# Office Action Summary

10/511,405

WEISNER ET AL.

## **DETAILED ACTION**

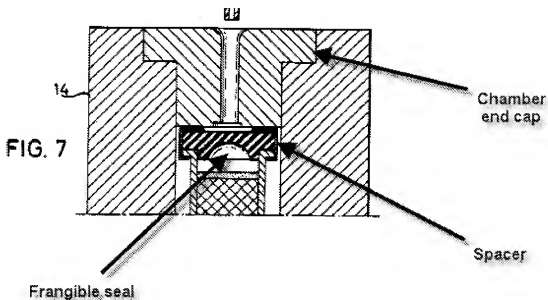
**Regarding claim 1**, the applicant's arguments indicate that there appears to still be some confusion as to exactly what component of Strecker's Fig. 7 the examiner is regarding as the spacer. Below is an excerpt from Fig. 7 of Strecker, in which the

examiner has labeled the spacer.

3. As can be seen above, the examiner's interpretation of Fig. 7 includes a spacer that is in contact with both the isotope generator and the end of the shielded chamber, thus functioning as a spacer. In use, Strecker's needle pierces both this spacer and the seal of the isotope generator, causing the spacer to surround the needle. Strecker indicates that "the junctions of nuclide generator 13 are provided with piercable stoppers made of an elastic material." This, in combination with Fig. 7 above, indicates that these stoppers provide both a compressible buffer and spacing.
4. Assuming, *arguendo*, that the above reasoning does not show the disclosure of a spacer by Strecker, alternate grounds of rejection under 35 U.S.C. 103(a) have been provided above, indicating that the use of such a spacer would have been obvious to one of ordinary skill in the art.
